Docket Nos. 50-269/270/287 JUN 2 0 1976

The Commission has issued the enclosed Amendments Nos. 2 2, 1 7, and 2 3 for Licenses Nos. DPR-38, DPR-47, and DPR-55 for the Oconee Nuclear Station, Units Nos. 1, 2, and 3. These amendments consist of changes to the Technical Specifications and are in response to your requests dated February 25, 1975, as revised May 7, 1976, and dated June 11, 1976.

ATTACHMENT TO LICENSE AMENDMENTS

Revise Appendix A as follows:

FIGURE 2.1-1B

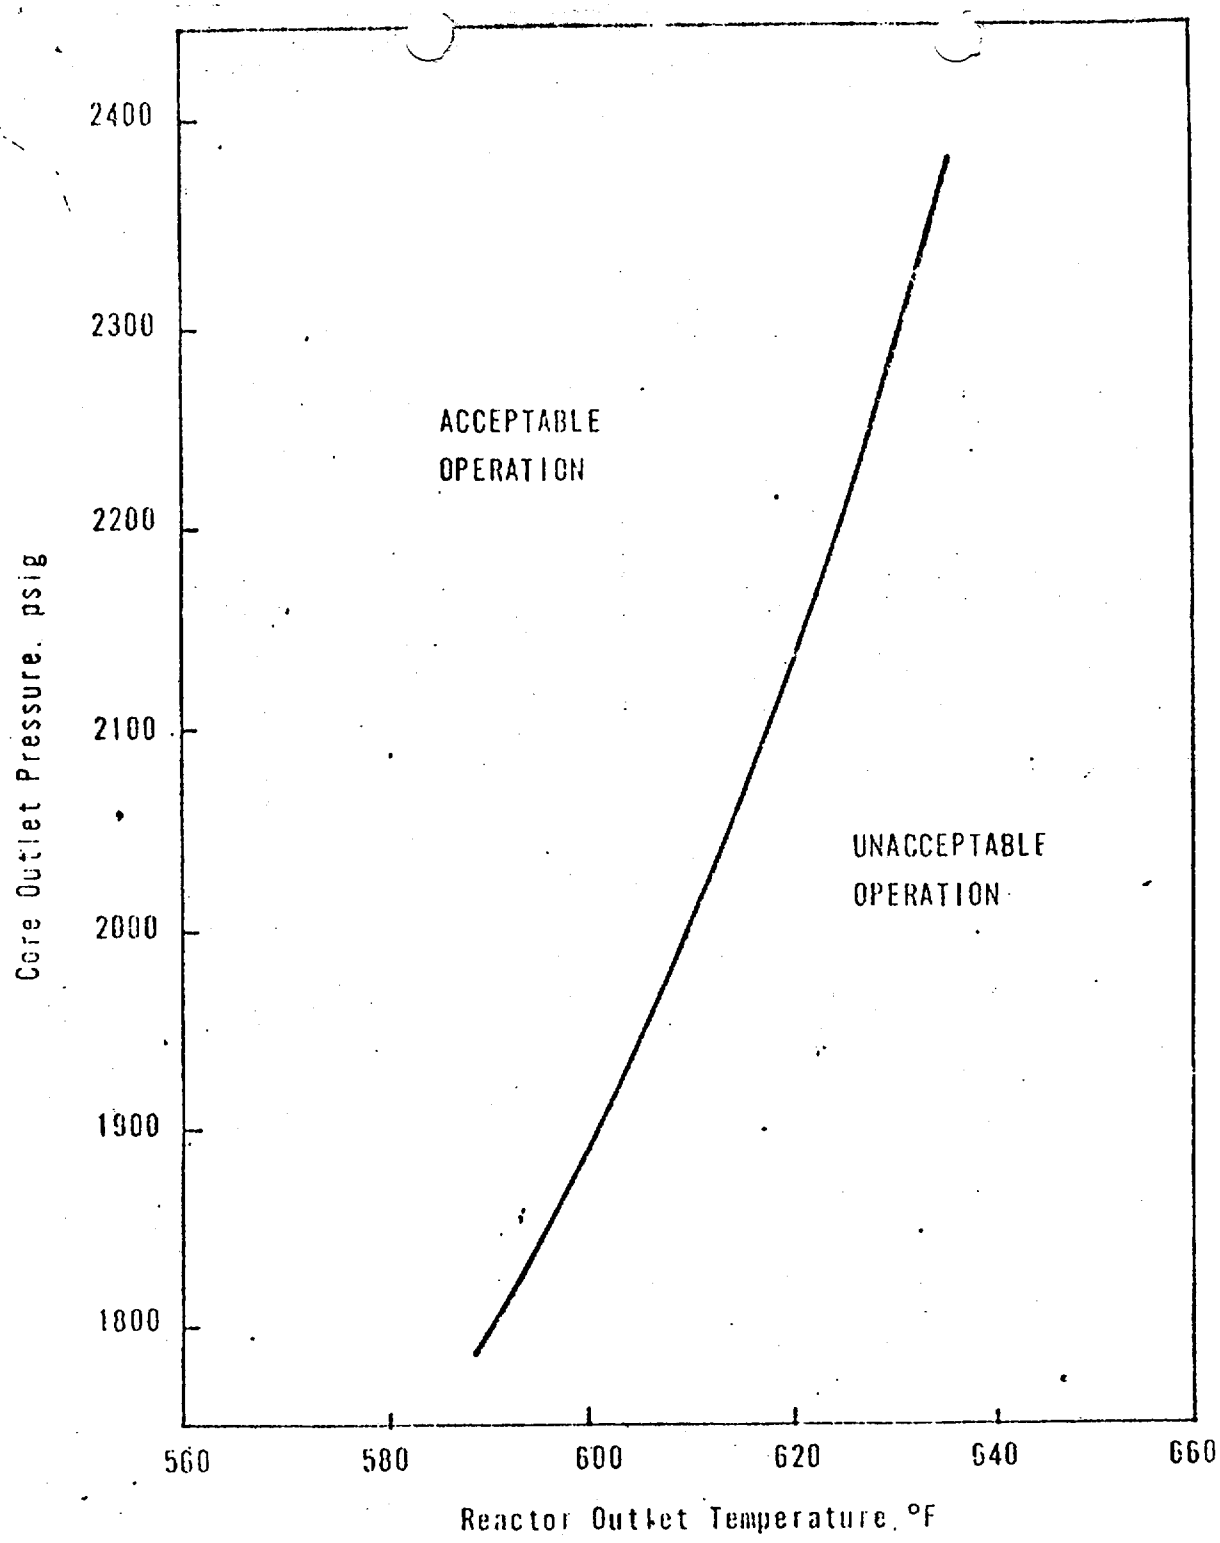
The curve presented in Figure 2.1-1B represents the conditions at which a minimum DNBR of 1.30 is predicted for the maximum possible thermal power (112 percent) when four reactor coolant pumps are operating (minimum reactor coolant flow is 141.3×10^6 lbs/hr). This curve is based on the following nuclear power peaking factors with potential fuel densification and fuel rod bowing effects: $F_q^N = 2.67$; $F_{\Delta H}^N = 1.78$; $F_z^N = 1.50$. The design peaking combination results in a more conservative DNBR than any other power shape that exists during normal operation.

The curve of Figure 2.1-1B is the most restrictive of all possible reactor coolant pump-maximum thermal power combinations shown in Figure 2.1-3B.

FIGURE 2.1-2B

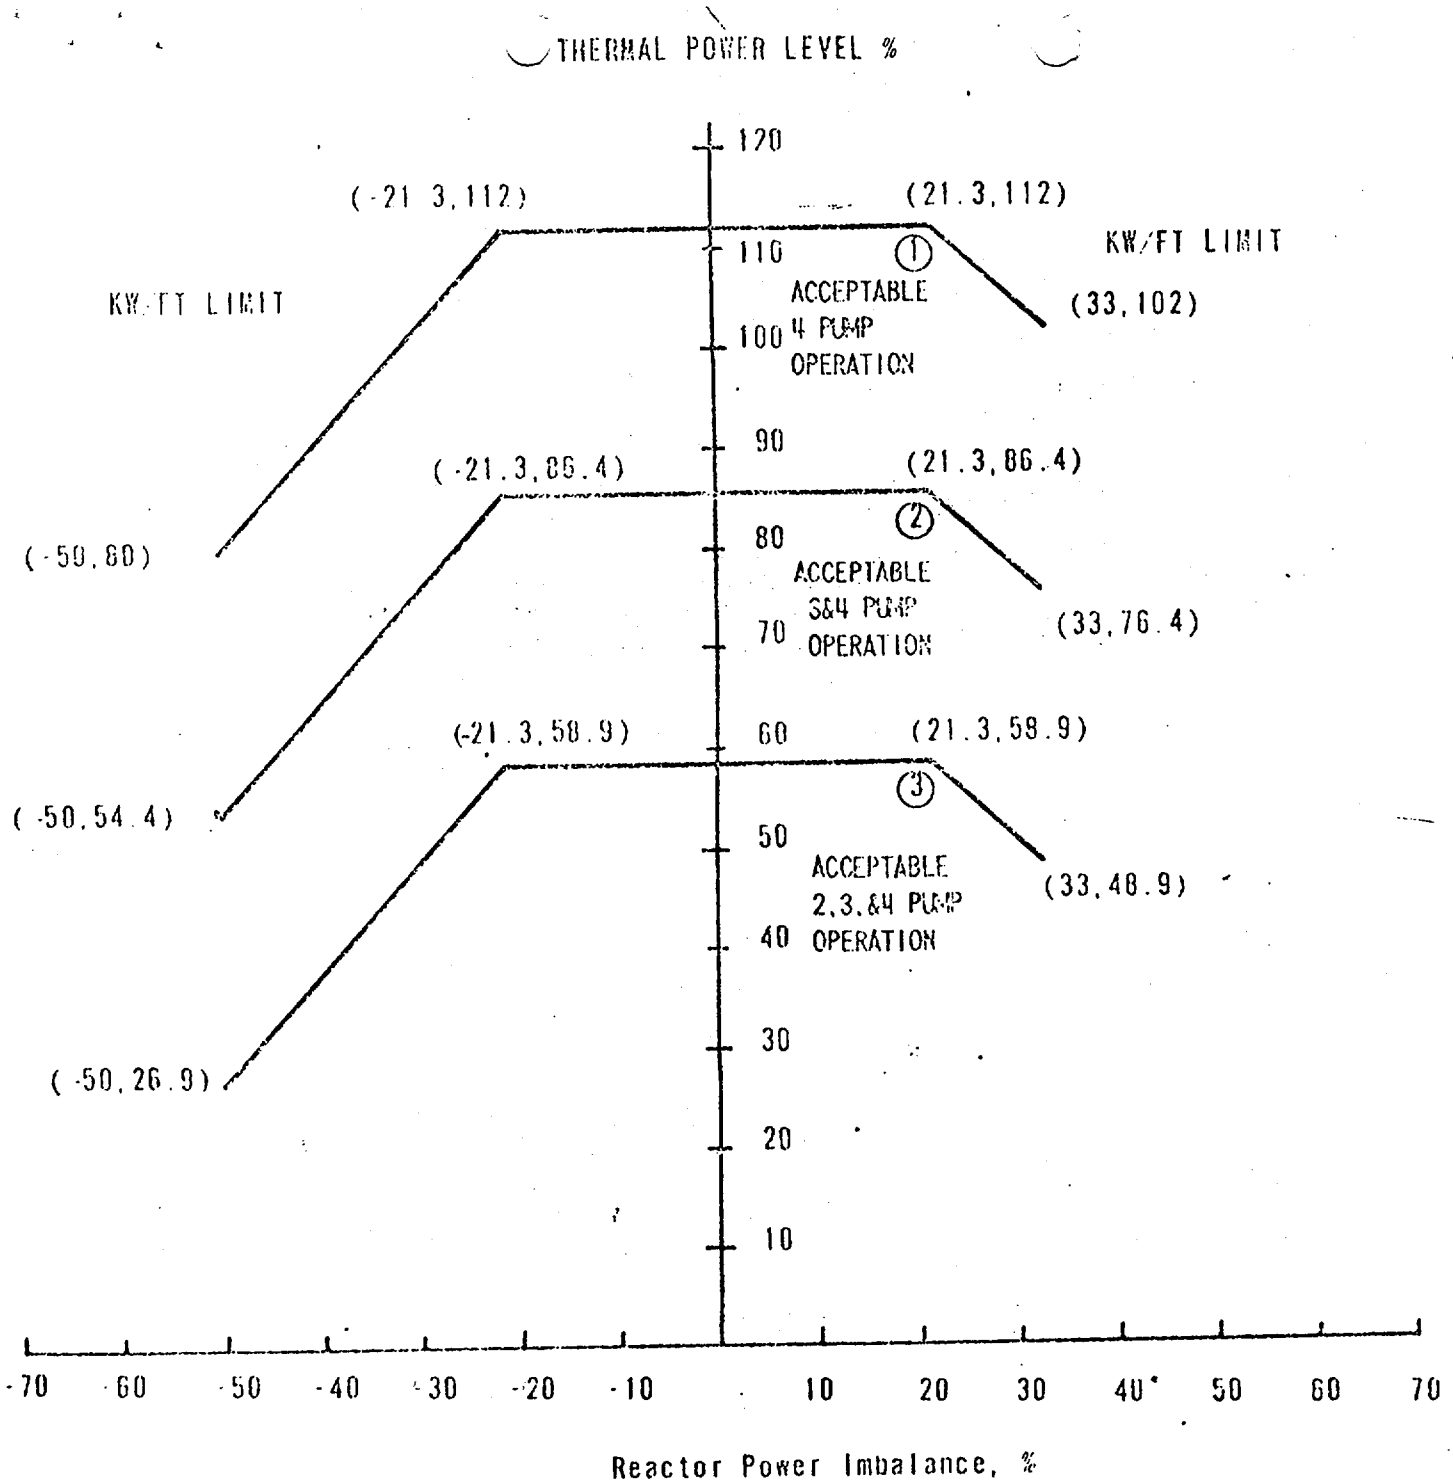
The curves of Figure 2.1-2B are based on the more restrictive of two thermal limits and include the effects of potential fuel densification and fuel rod bowing:

1. The 1.30 DNBR limit produced by a nuclear peaking factor of $F_q^N = 2.67$ or the combination of the radial peak, axial peak and position of the axial peak that yields no less than a 1.30 DNBR.

2. The combination of radial and axial peak that causes central fuel melting at the hot spot. The limit is 19.8 kw/ft for Unit 2.

The specified flow rates for Curves 1, 2, and 3 of Figure 2.1-2B correspond to the expected minimum flow rates with four pumps, three pumps, and one pump in each loop, respectively.

FIGURE 2.1-3B

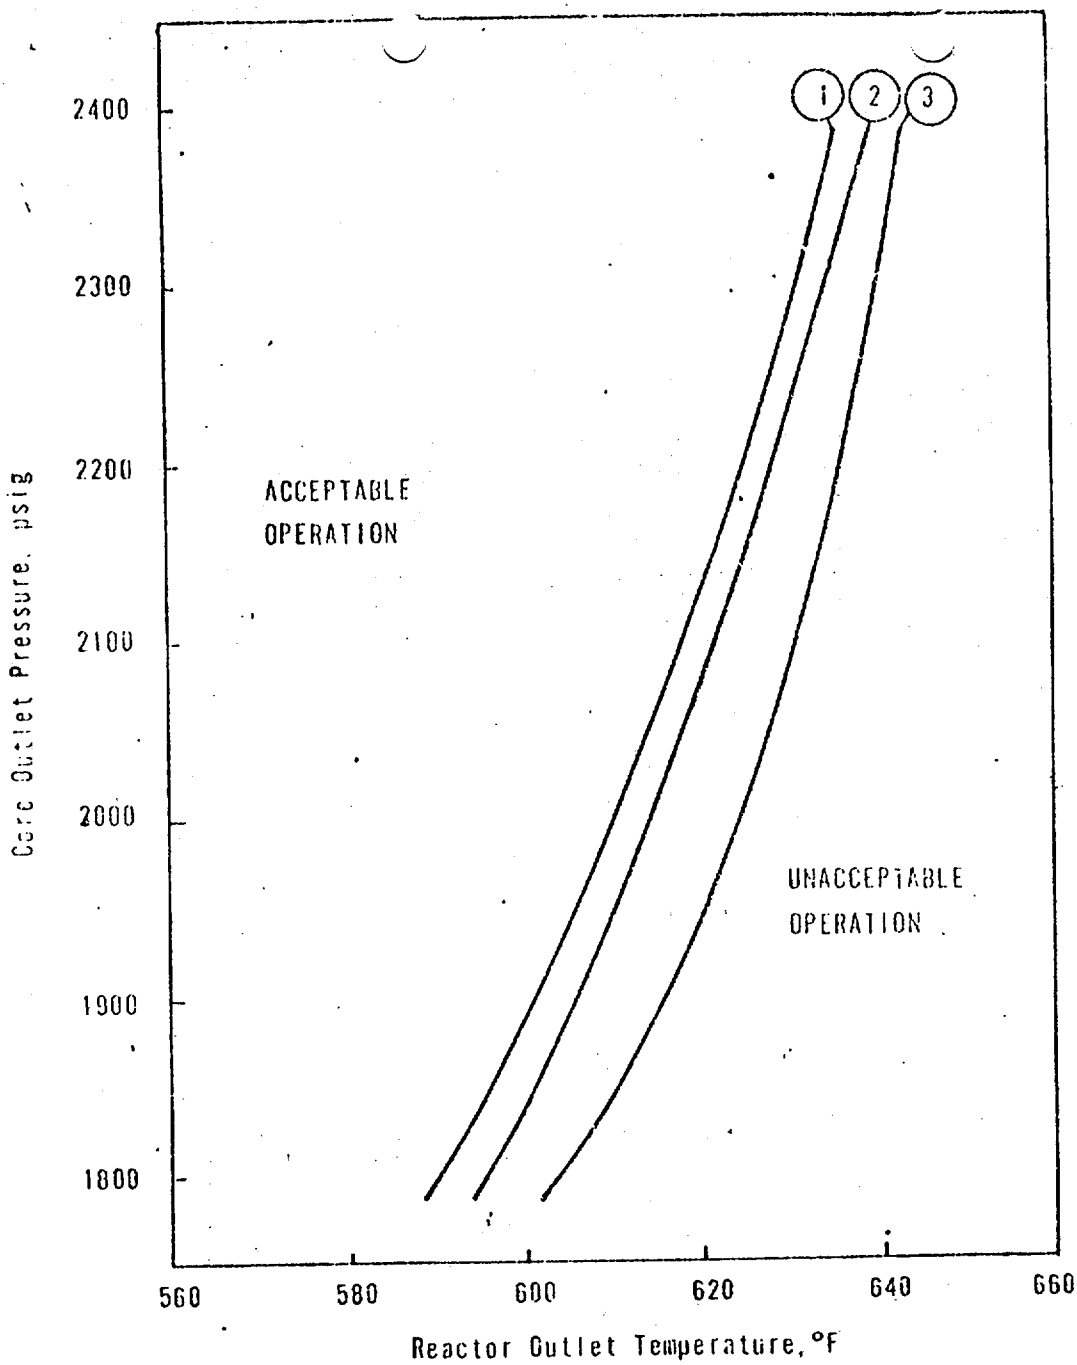
The maximum thermal power for three-pump operation is 86.4 percent due to a power level trip produced by the flux-flow ratio 74.7 percent flow x 1.07 = 79.9 percent power plus the maximum calibration and instrument error. The maximum thermal power for other coolant pump conditions are produced in a similar manner.

For each curve of Figure 2.1-3B, a pressure-temperature point above and to the left of the curve would result in a DNBR greater than 1.30 or a local quality at the point of minimum DNBR less than 22 percent for that particular reactor coolant pump situation. The 1.30 DNBR curve for four-pump operation is more restrictive than any other reactor coolant pump situation because any pressure/temperature point above and to the left of the four-pump curve will be above and to the left of the other curves.

FIGURE 2.3-1B

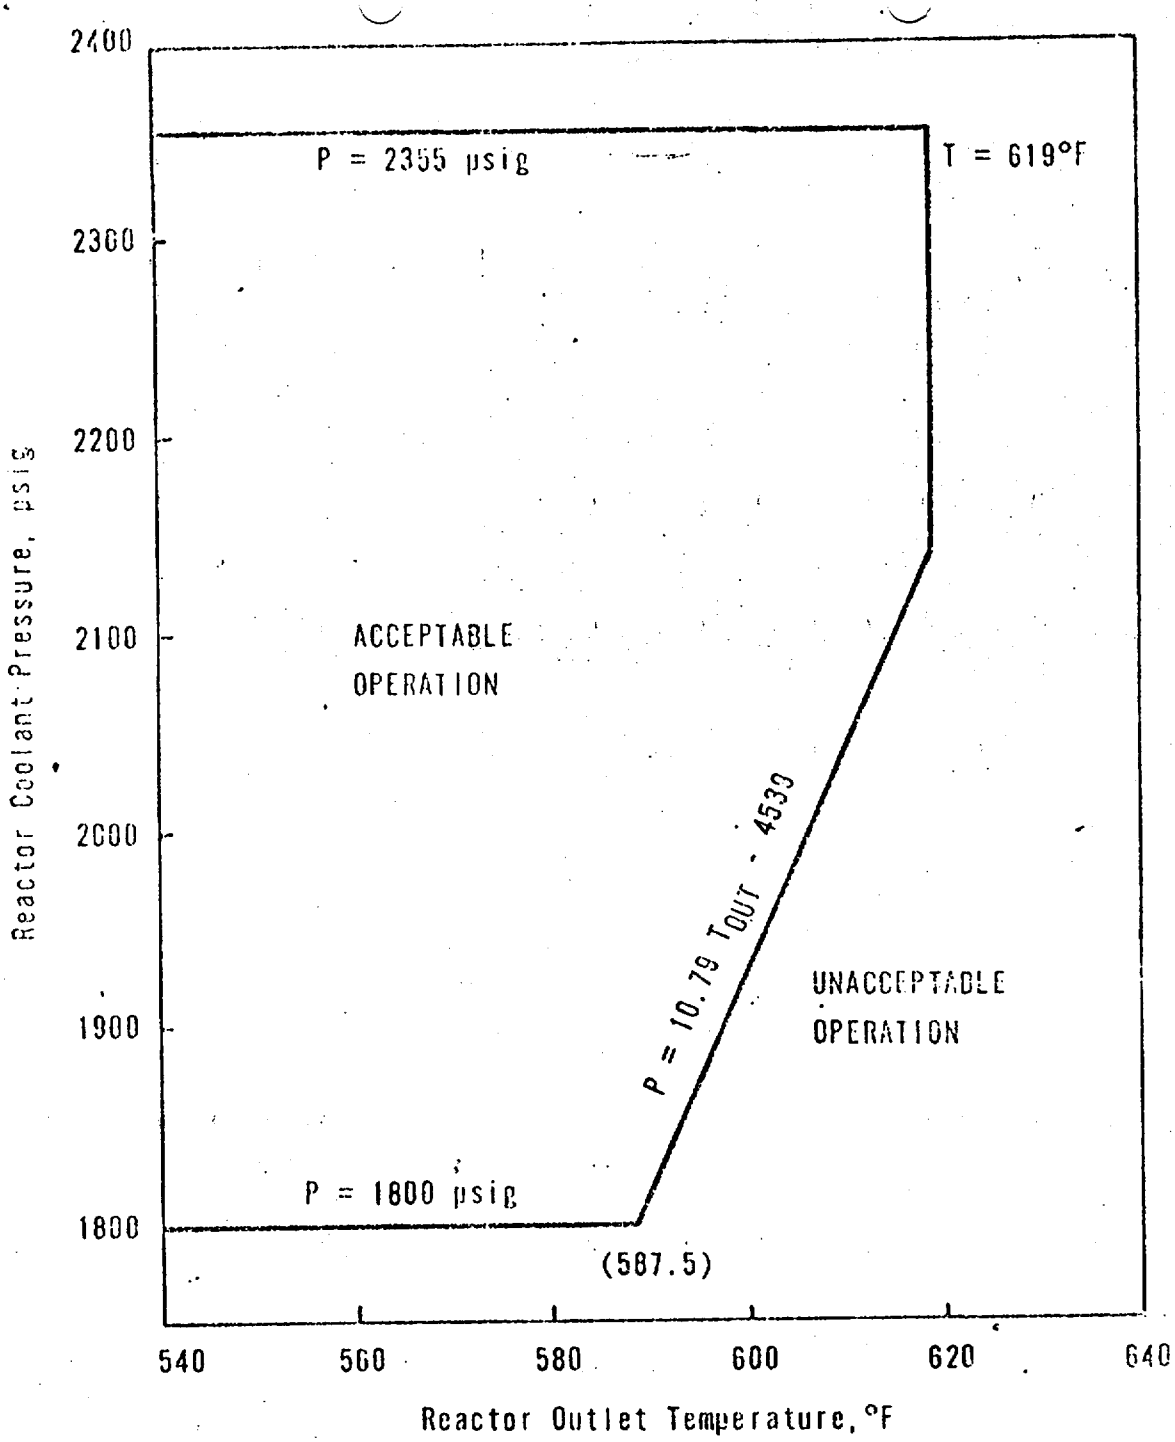
During a startup accident from low power or a slow rod withdrawal from high power, the system high pressure set point is reached before the nuclear overpower trip set point. The trip setting limit shown in Figure 2.3-1A - Unit 1
2.3-1B - Unit 2
2.3-1C - Unit 3

for high reactor coolant system pressure (2355 psig) has been established to maintain the system pressure below the safety limit (2750 psig) for any design transient. (1)

The low pressure (1800) psig and variable low pressure $(11.14\ T_{out} - 4706)$ trip
(1800) psig $(10.79\ T_{out} - 4539)$
(1800) psig $(16.25\ T_{out} - 7756)$
setpoints shown in Figure 2.3-1A have been established to maintain the DNB
2.3-1B
2.3-1C
ratio greater than or equal to 1.3 for those design accidents that result in a pressure reduction. (2,3)

The high reactor coolant outlet temperature trip setting limit (619 F) shown in Figure 2.3-1A has been established to prevent excessive core coolant
2.3-1B
2.3-1C
temperatures in the operating range. Due to calibration and instrumentation errors, the safety analysis used a trip set point of 620°F.

FIGURE 2.3-2B

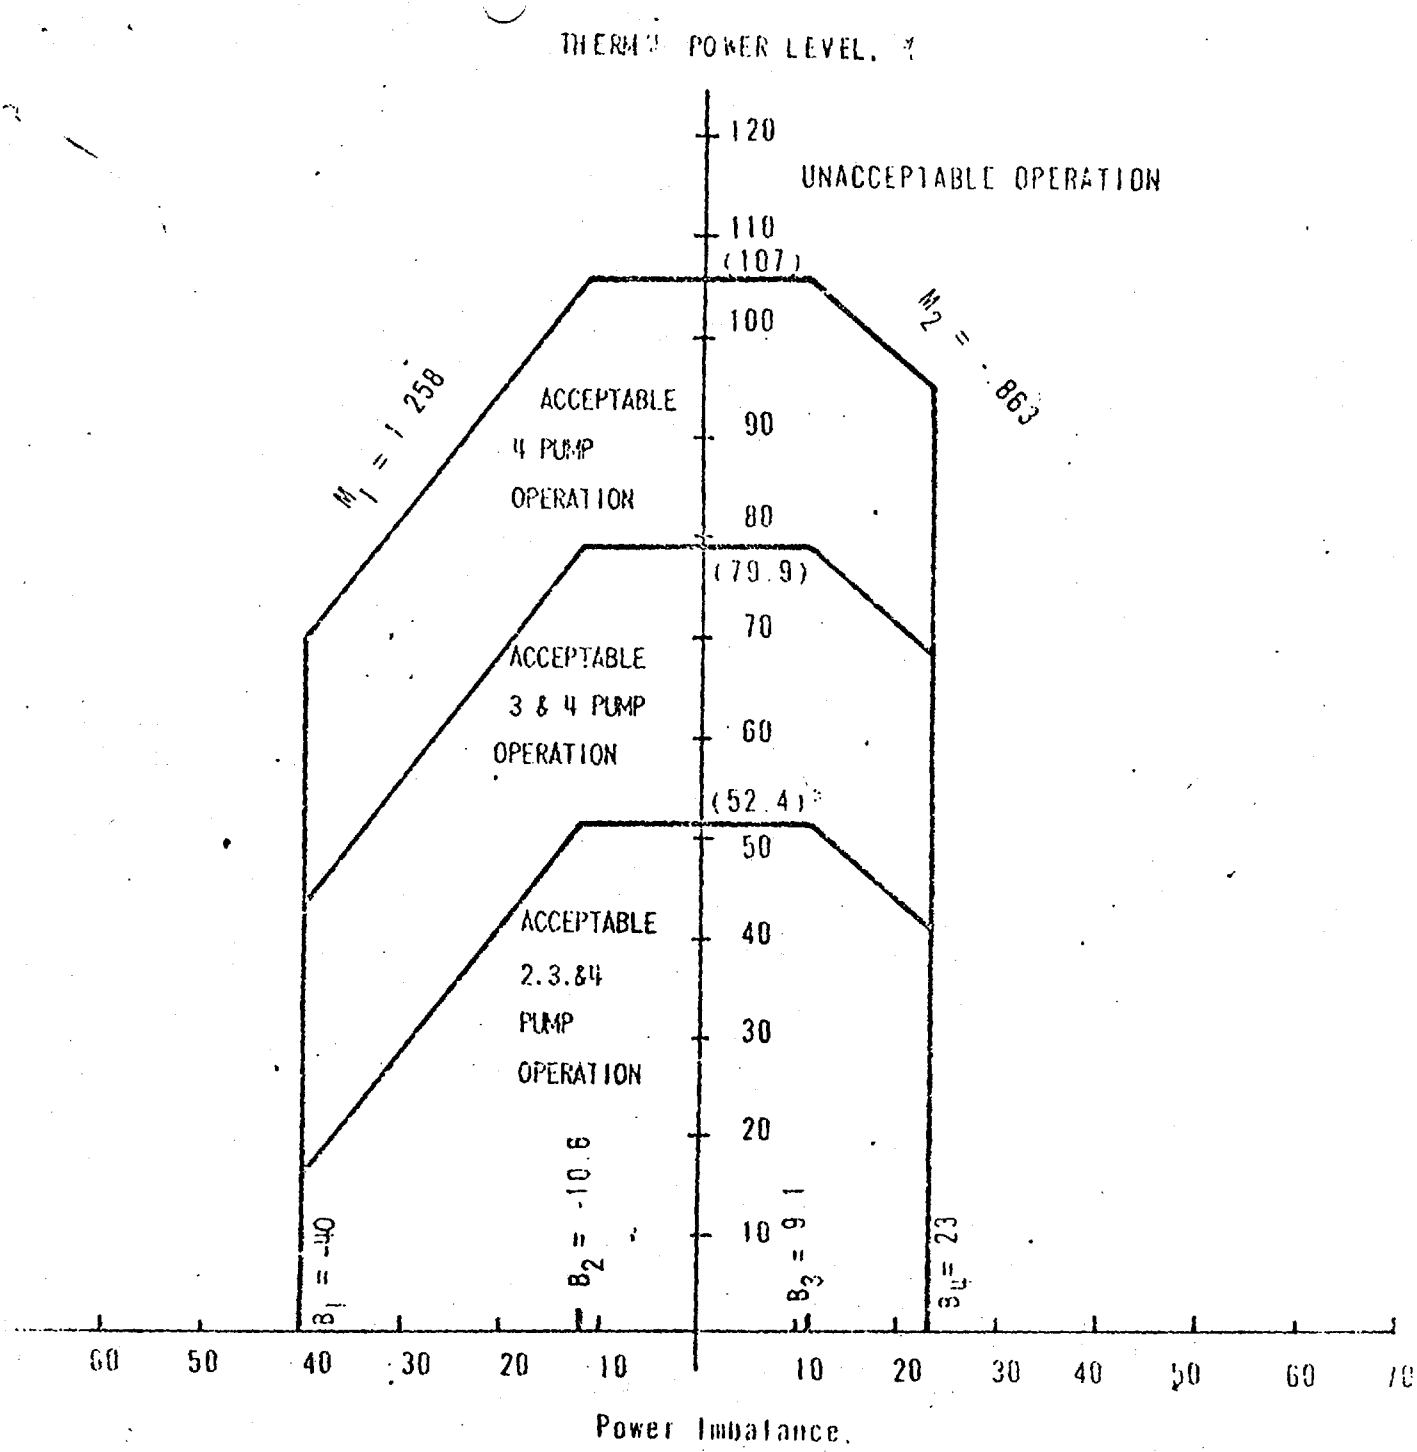
The power-imbalance boundaries are established in order to prevent reactor thermal limits from being exceeded. These thermal limits are either power peaking kw/ft limits or DNBR limits. The reactor power imbalance (power in the top half of core minus power in the bottom half of core) reduces the power level trip produced by the power-to-flow ratio such that the boundaries of Figure 2.3-2A - Unit 1 are produced. The power-to-flow ratio reduces the power

2.3-2B - Unit 2
2.3-2C - Unit 3

level trip and associated reactor power/reactor power-imbalance boundaries by 1.055%-Unit 1 for a 1% flow reduction.

1.07% - Unit 2
